For Official Use Only 請勿填寫此欄	Application No. 申請編號	A/YC-PH/1077
	Date Received 收到日期	2025-07-08

1. This Planning Statement is submitted to the Town Planning Board (“the Board”) on behalf of Mr. YIK King Kung Philip (“the Applicant”) in support of the planning application for ‘Proposed Temporary Warehouse (excluding Dangerous Goods Godown) with Ancillary Office and associated Filling of Land for a Period of 3 Years’ (“the Proposed Development”) on Lots 29 (Part), 33 (Part) and 35 (Part) in D.D. 111 and Adjoining Government Land, Pat Heung, Yuen Long (“the Site”) under Section 16 of the Town Planning Ordinance.

We would like to submit a response-to-comment, drainage proposal (Plans 6.1 and 6.2) and hydraulic calculations to respond to the comments from Transport Department, Drainage Services Department and Lands Department.

Plan 6.1b (P 25025)

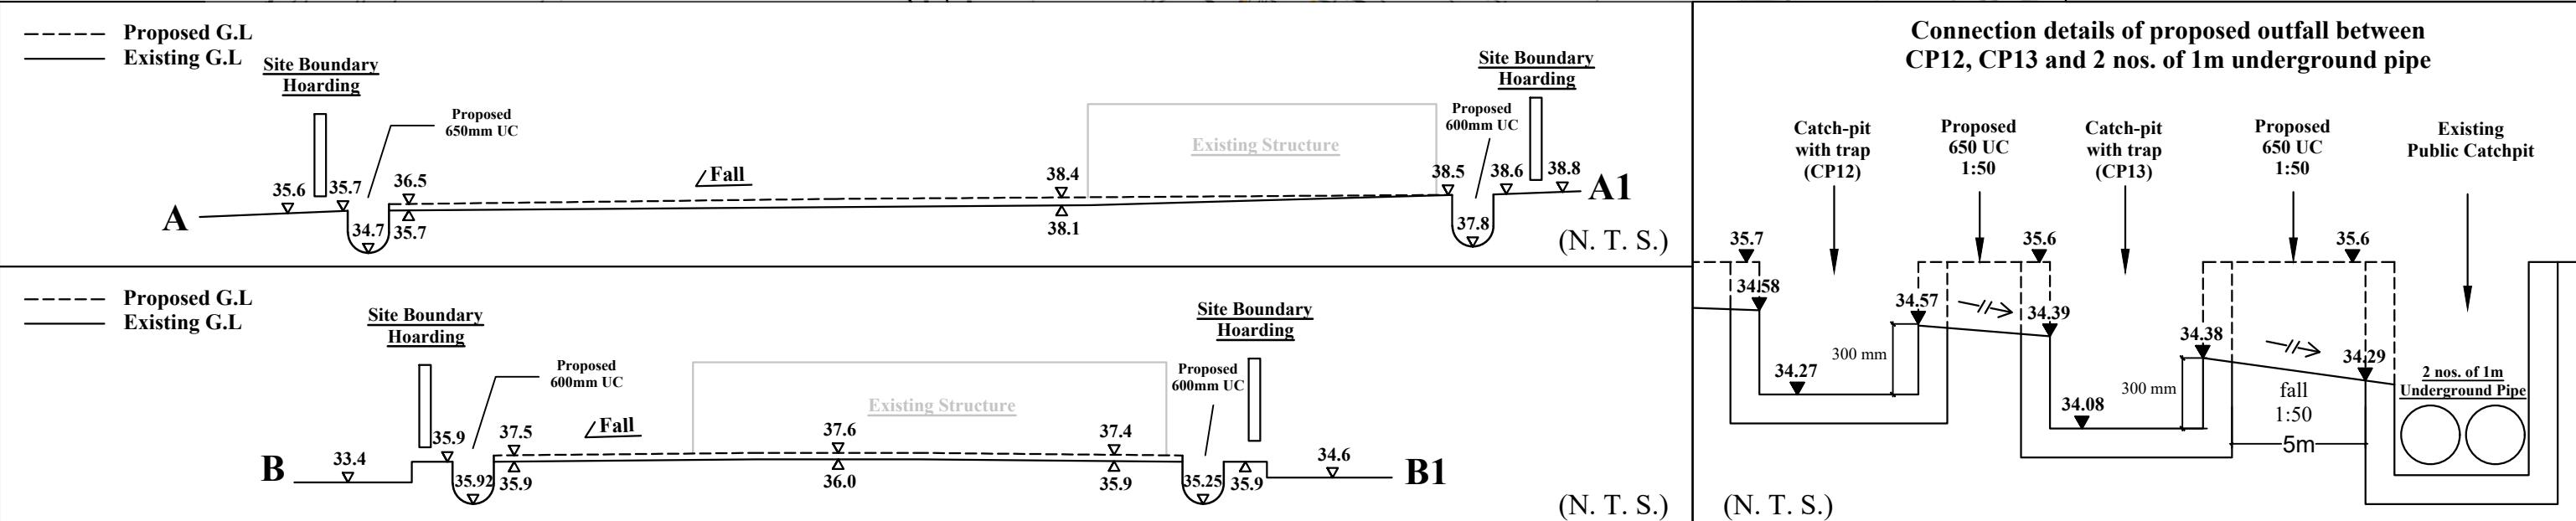
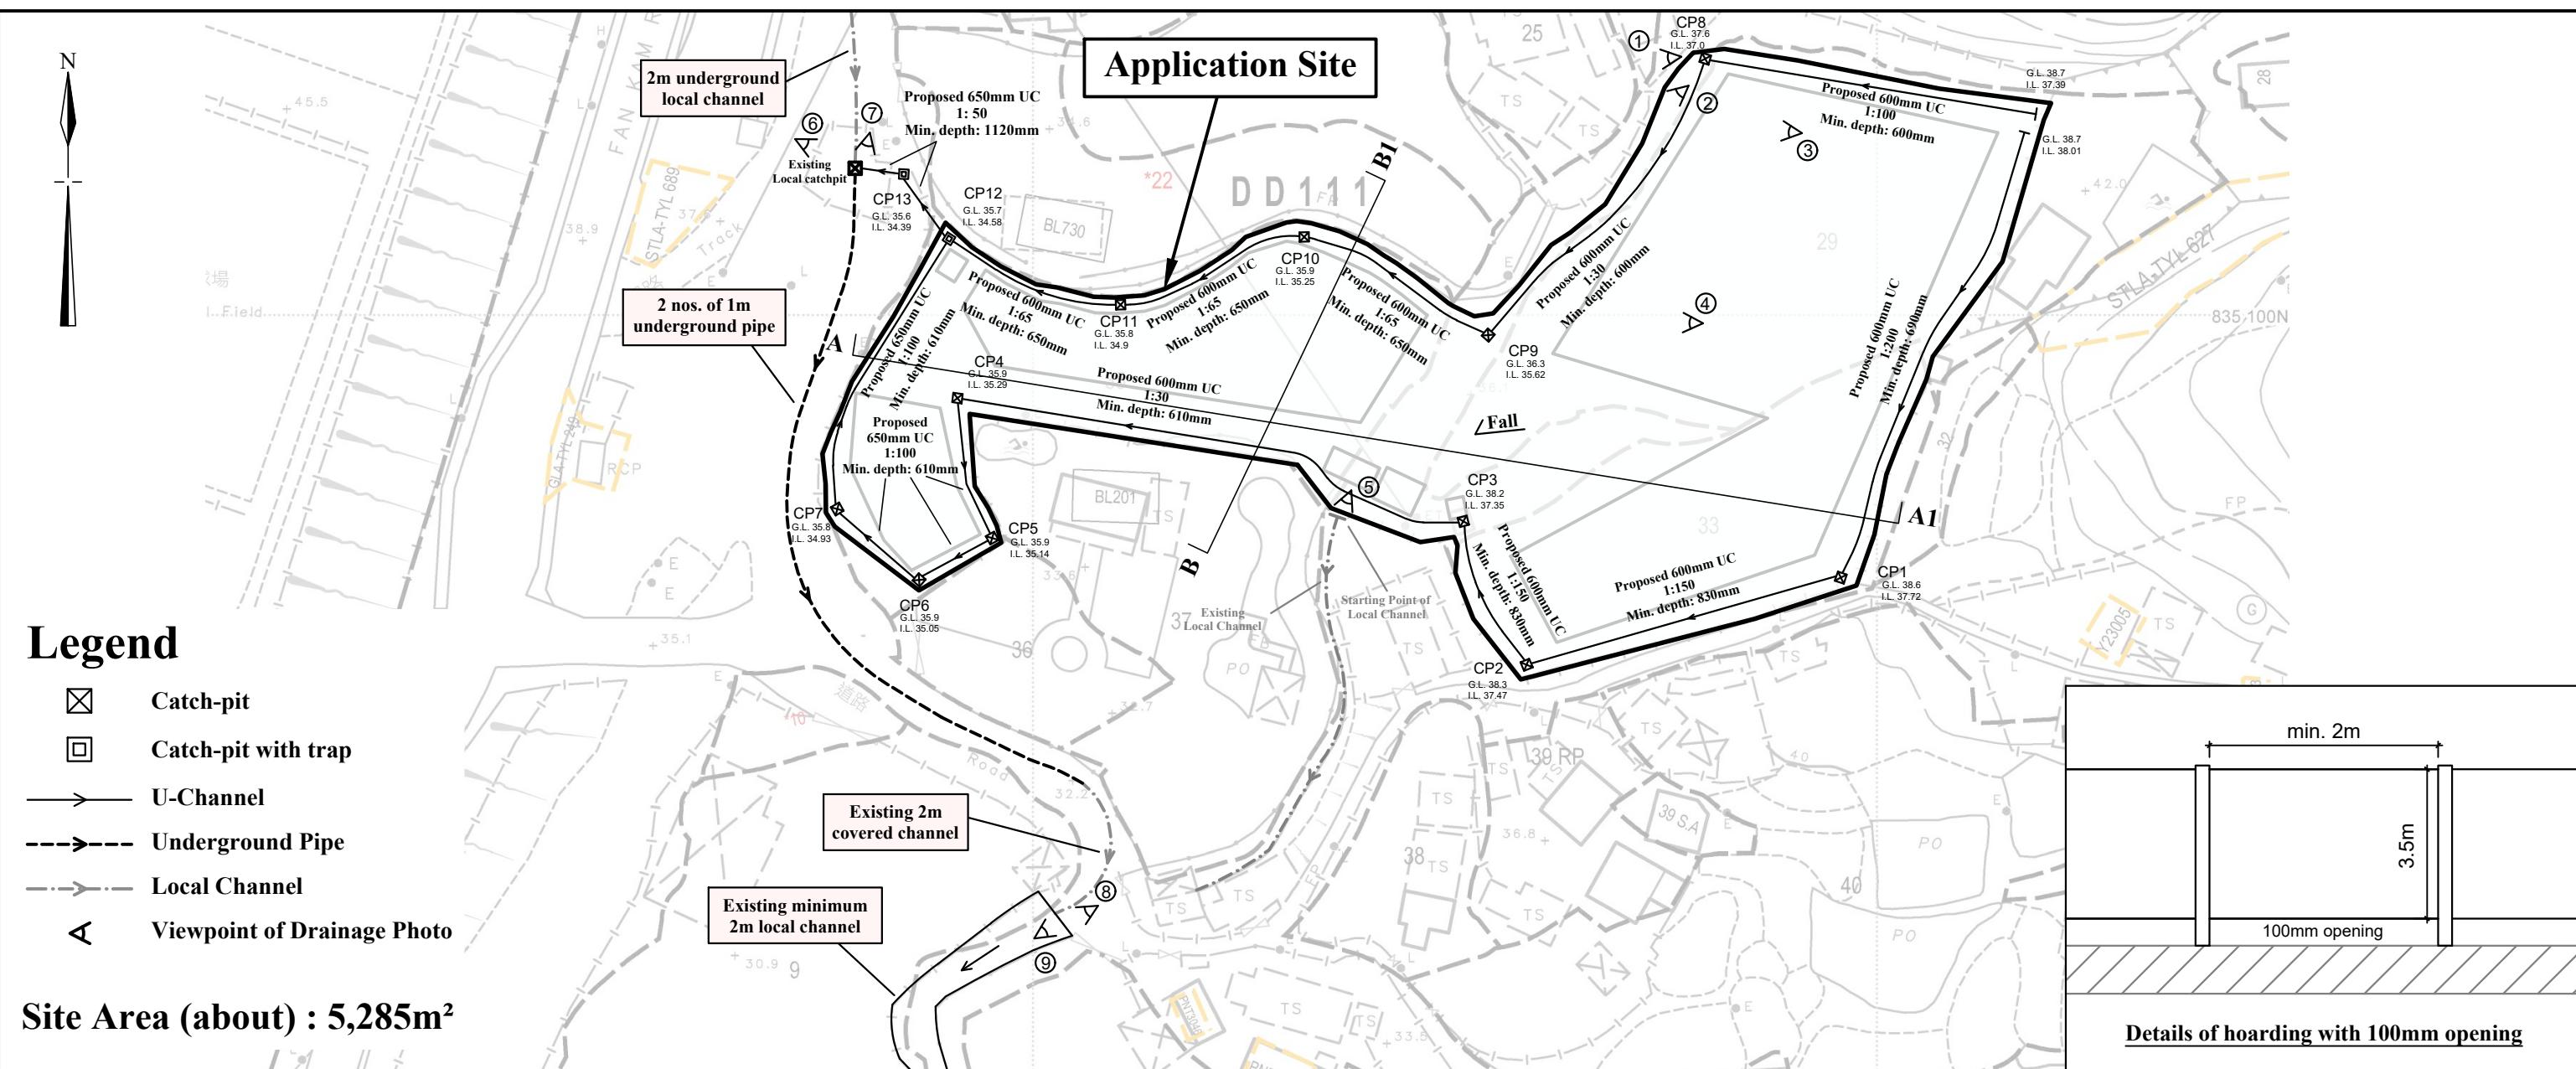
Comments	Responses
i. It is noted that the site area is 5285m ² and the ground to the north of the application site is generally higher. Since the overland flow from the adjacent lands shall be probably intercepted, external catchment shall be considered in the calculation (i.e. Lots 22, 24, 25 and 26, etc. in D.D. 111). Please also make reference to the latest Technical Note No. 1 issued by DSD for more details in preparing the drainage proposal. Please upgrade all drainage facilities size accordingly.	<p>The ground level of the ground to the north is +34.6mPD as shown in Plan 6.1b. The ground level of the western side of the application site is +36.5mPD. Thus, the ground to the north of the application site is lower than the application site.</p> <p>The U-channels within the site are upgraded to 600mm. Please refer to Plan 6.1b.</p>
ii. Referring to R-to-C, please advise whether any section of the said local ditch is within the application site. If affirmative, please ensure that the existing local ditch and the relevant discharge connection(s) should be maintained due to the proposed development. Please also provide adequate measures and drainage facilities to intercept their flow properly. Please indicate the above on the drainage plan for reference.	No section of the said local ditch is within the application site. Please refer to attached site photographs and Plan 6.1b for the viewpoints of the photographs.

iii. Catchpit should be provided at the turning point of the proposed u-channel.	Noted. Additional catchpits are provided. Please refer to Plan 6.1b.
iv. Please advise if any site formation/levelling works to be carried out under this application. Cross sections showing the existing and proposed ground levels of the captioned site with respect to the adjacent areas should be given. Referring to cross sections A-A and B-B, please note that the proposed peripheral surface channels shall be provided along the site boundary <u>at the original/existing ground level</u> (instead of the revised ground level) to collect the surface runoff accrued on the application site and to intercept the overland flow from the adjacent lands.	<p>There are site formation/levelling works to be carried out under this application. Please refer to the cross sections at Plan 6.1b showing the existing and proposed ground levels.</p> <p>The proposed peripheral surface channels are provided along the site boundary at the original/existing ground level. Please refer to the Sections at Plan 6.1b.</p>

Comments	Responses
v.	Please indicate clearly the full alignment of the discharge path from the application site all the way down to the ultimate discharge point (e.g. a well-established stream course/public drainage system).	Please refer to attached photographs.
vi.	The existing 500 mm u-channel, to which the proposed to discharge the stormwater from the subject site was not maintained by this office. Please resolve any conflict/disagreement arisen for discharging the runoff from the application site(s) to the proposed discharge point(s). Moreover, please ensure that this drainage system and the existing downstream drains/channels/streams have adequate capacity to convey the additional runoff from the application site(s). Regular maintenance should be carried out by the applicant(s) to avoid blockage of the system.	Noted.
vii.	Further to (vi) above, since there is no record of the said discharge path, please provide site photos to demonstrate its presence and existing condition.	The discharge path is updated to discharge to an existing catchpit where there are 2 nos. of 1m underground pipe. Please refer to Plan 6.1b and viewpoint photographs 6 and 7.

Plan 6.3
(P 25025)

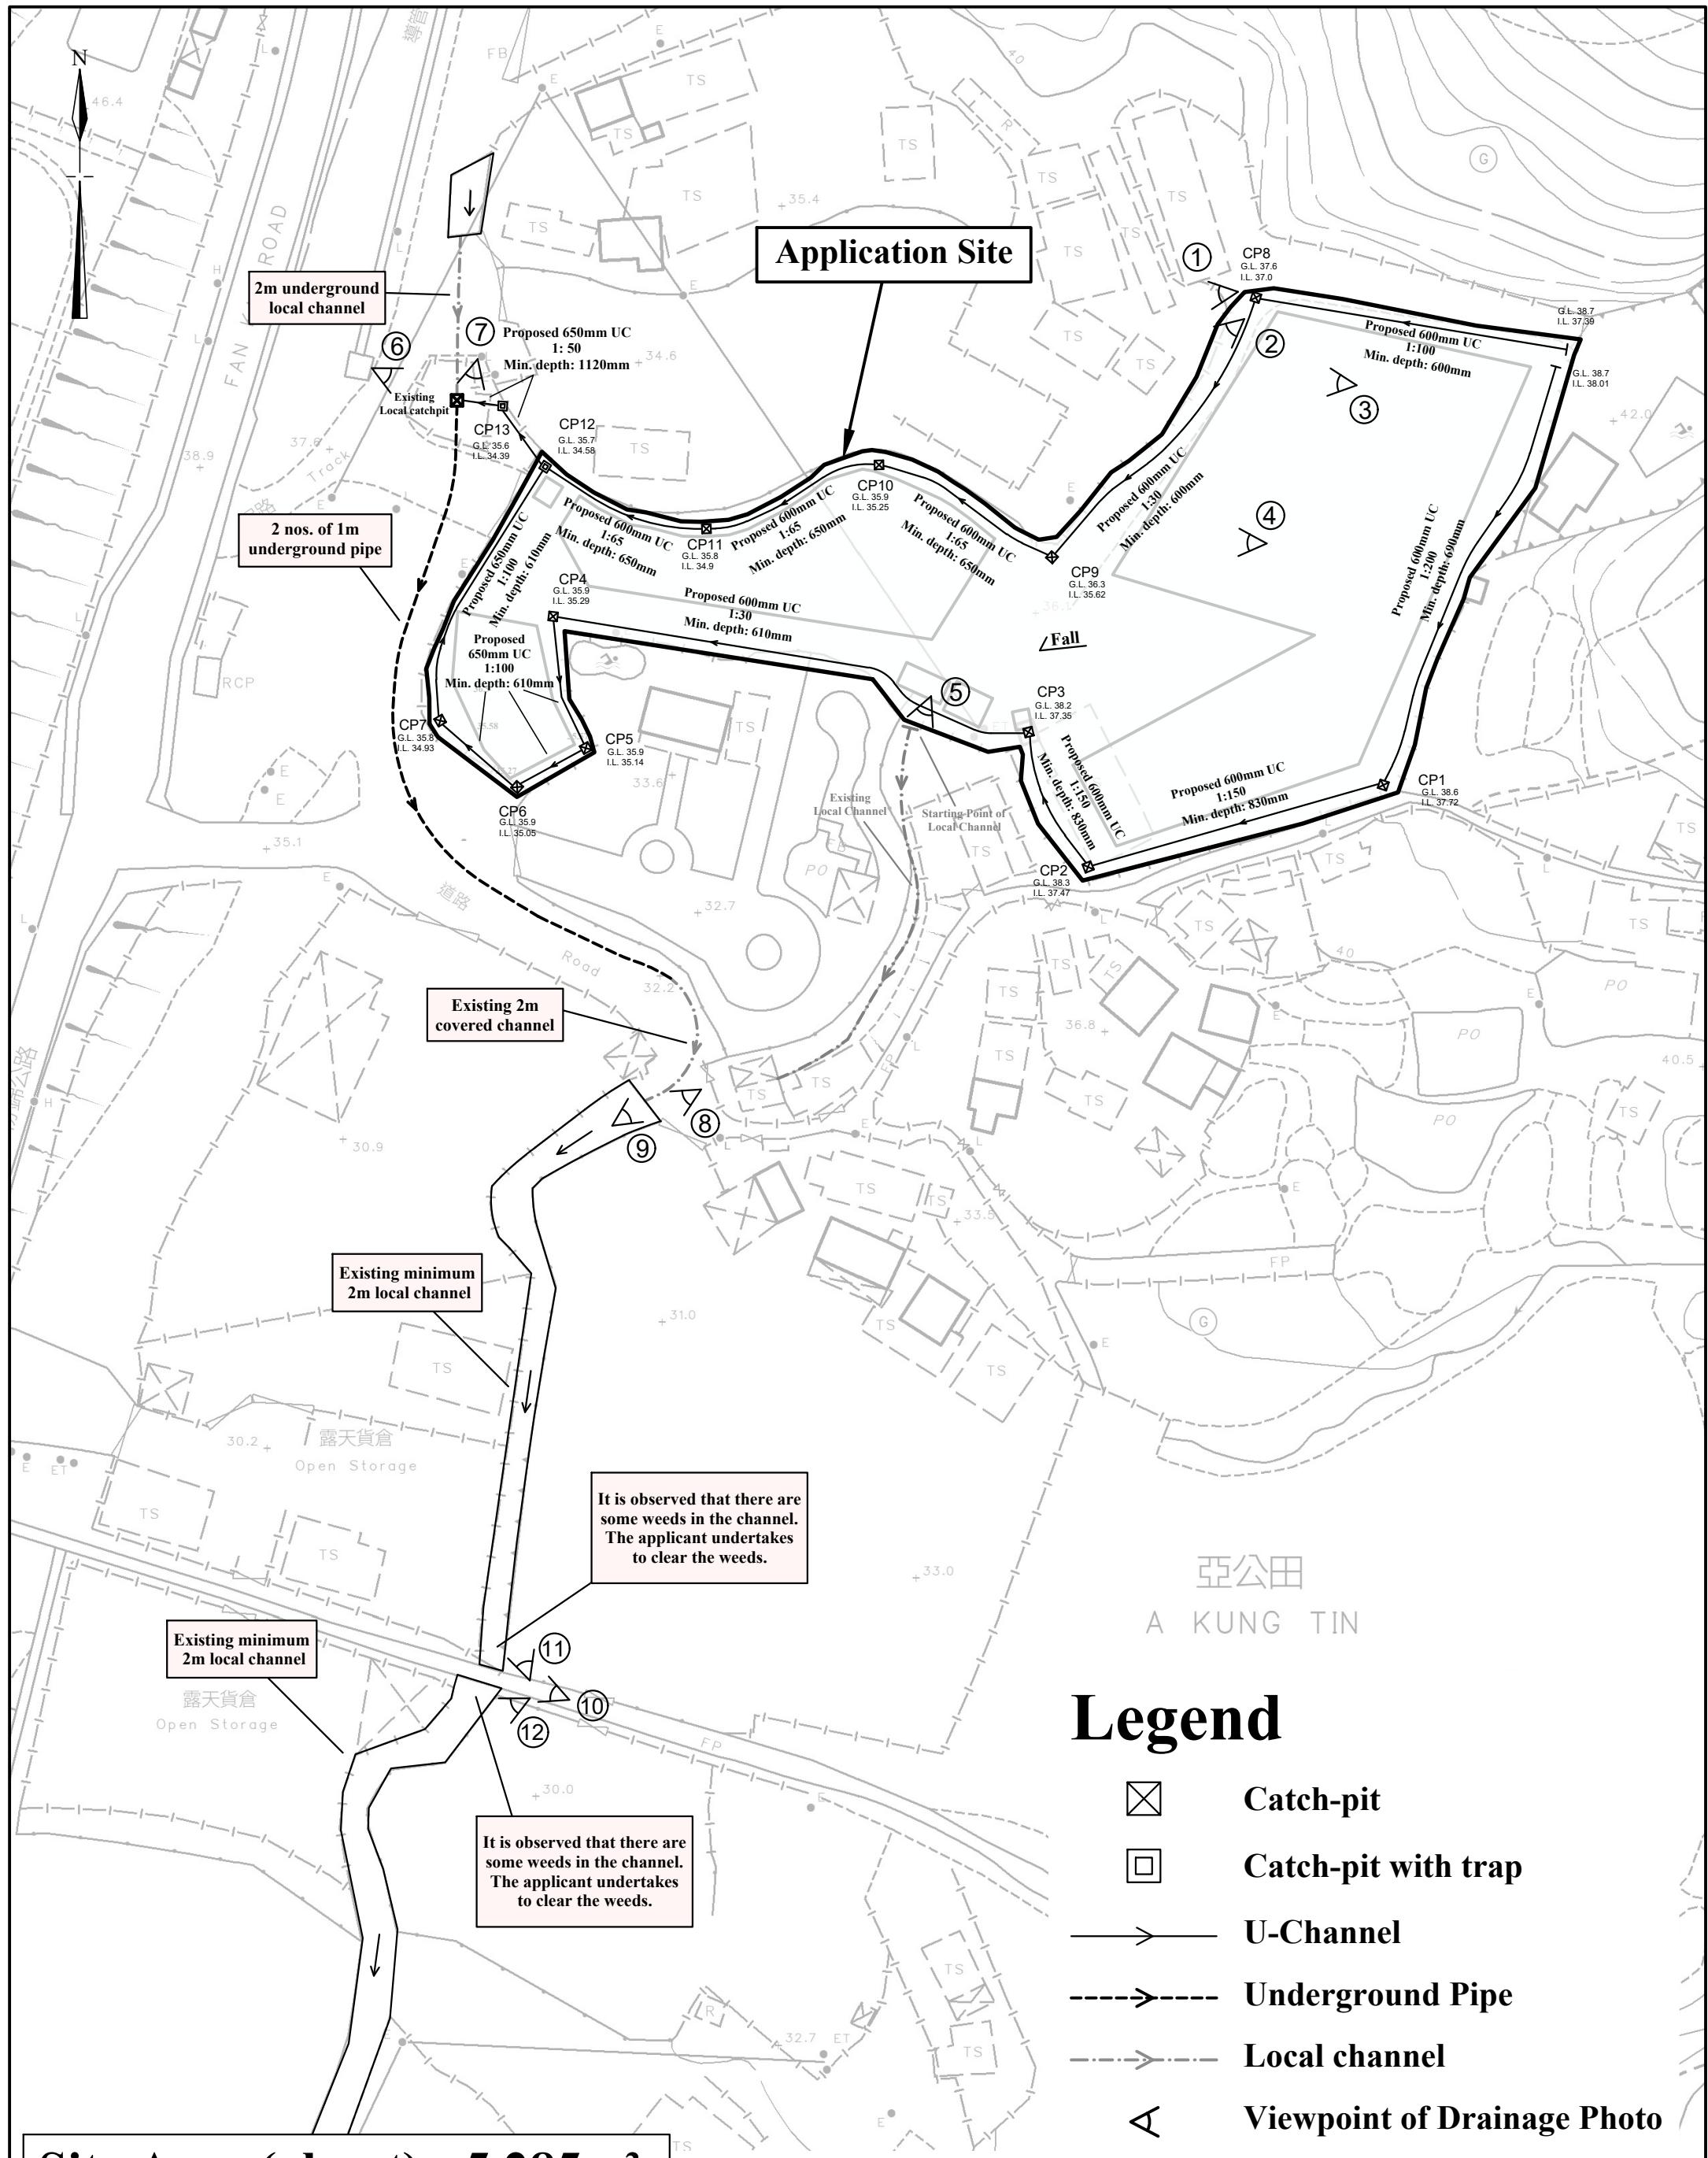
It is noted that there are some overgrown vegetations and silting in the downstream channel outside the site (see Plan 6.3 and viewpoints 10-12). The applicant undertakes to clear these overgrown vegetation and silting.
